APPLICATION NO:
F/2002/8176

LOCATION:
96 Redhatch Drive, Earley Reading.

PROPOSAL:
Proposed two storey side extension to dwelling and single storey rear extension plus conservatory.

F/2002/8176
PROPOSED AMENDMENTS TO PLANNING CONSENT FOR A TWO STOREY SIDE EXTENSION & SINGLE STOREY REAR EXTENSION PLUS CONSERVATORY AT 96 REDHATCH DRIVE, EARLEY

96 Redmatch Drive
Farcey

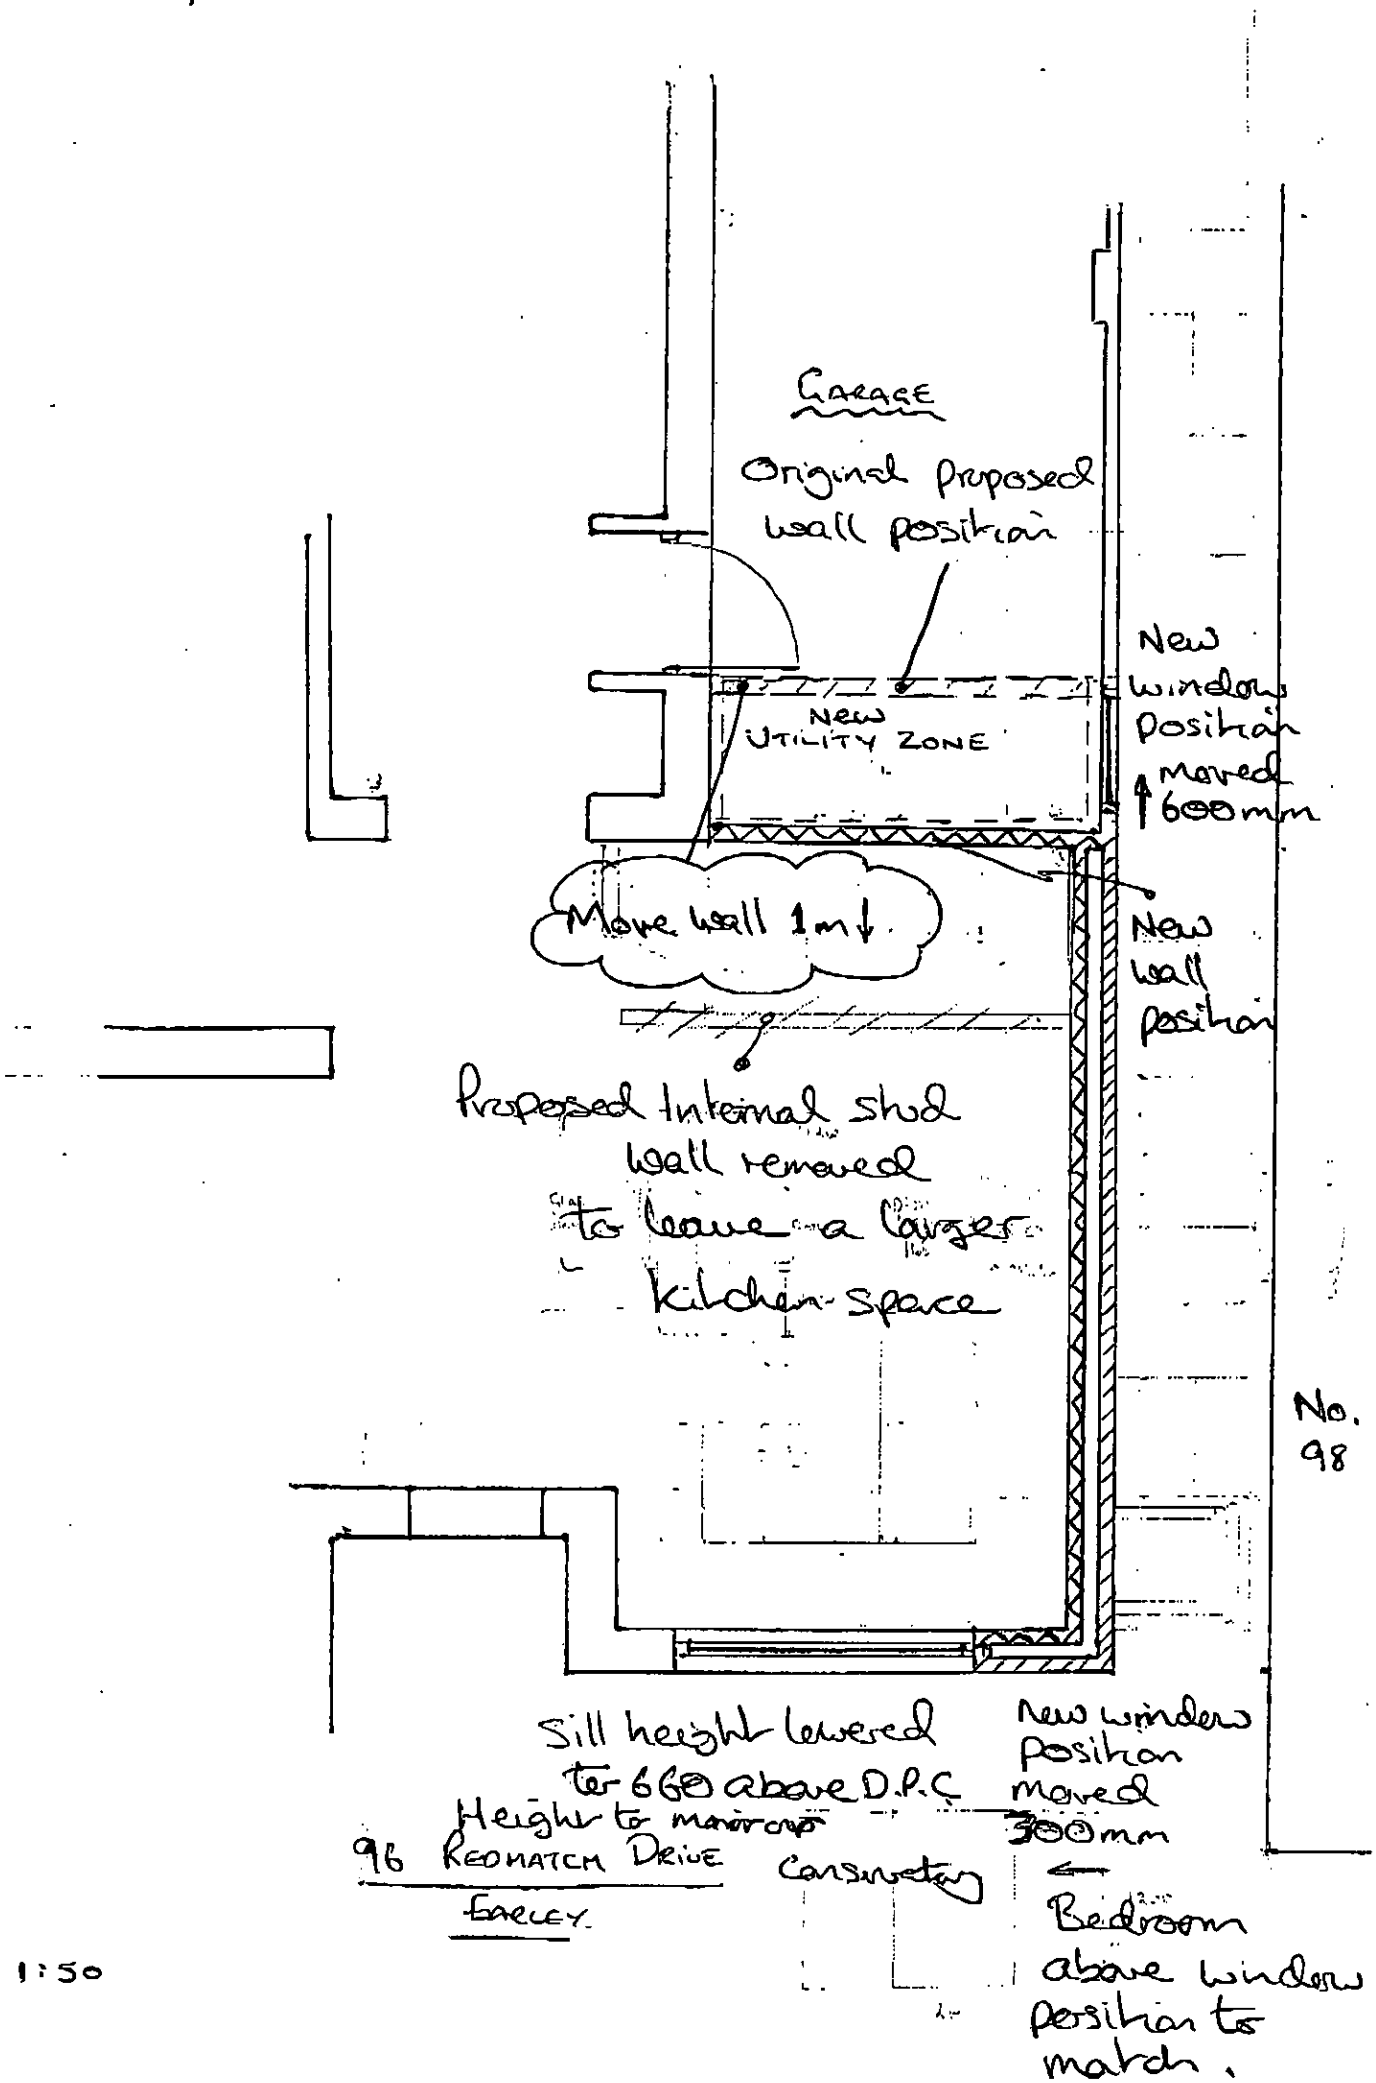
To Andy Brett - Building Control / Daniel Grigg - Planning Services
Fax number 974 6385 974 6484
From Neale Farwell
Total pages 4
Date 23/09/03
RE: FP/2003/4213 & F2002/8176-96 REDHATCH DRIVE. EARLEY

I would appreciate your early attention / advise to the amendments I am proposing, as my builder will have shortly completed below ground drainage, and floor slab level. Can you please confirm if my proposals would be deemed minor amendments.

The principle changes are to the kitchen and rear of the building.

(i) Remove internal shed wall within kitchen.
(ii) Move internal garage wall further back (creates larger kitchen & garage / utility zone in garage)
(iii) Move side window 600mm into utility zone in garage
(iv) Move both kitchen and rear bedroom window above kitchen 300mm from edge of building.
(v) Lower sill height of window by 500mm to match Conservatory
(vi) Change end of conservatory from hip to gable.

I detail below - in two sections - the proposed alterations that will require planning permission and those that will be treated as minor amendments, not requiring permission.

*Amendments that **will** require planning permission*

- The proposed insertion of a velux rooflight and / or a sunpipe dome in the east facing elevation. These will require planning permission due to Condition 5 of planning consent F/2003/8176 which states that no additional windows or similar openings shall be constructed in the first floor level or above in the east facing elevation.
- The proposed change to the roof form of the conservatory from a hip to a gable end. This will require planning permission as there will be an increase in the volume (measured externally) of the proposal.

*Alterations that can be treated as minor amendments, **not** requiring planning permission*

- Relocation of the internal wall between the garage and the utility room to create an enlarged garage.
- The re-siting of the ground floor side window in the east facing elevation.
- The re-siting of the kitchen window and bedroom window above the kitchen, in the rear facing elevation.
- The lowering of the sill height of the window in the rear elevation of the conservatory.
- The removal of the internal stud wall in the kitchen.
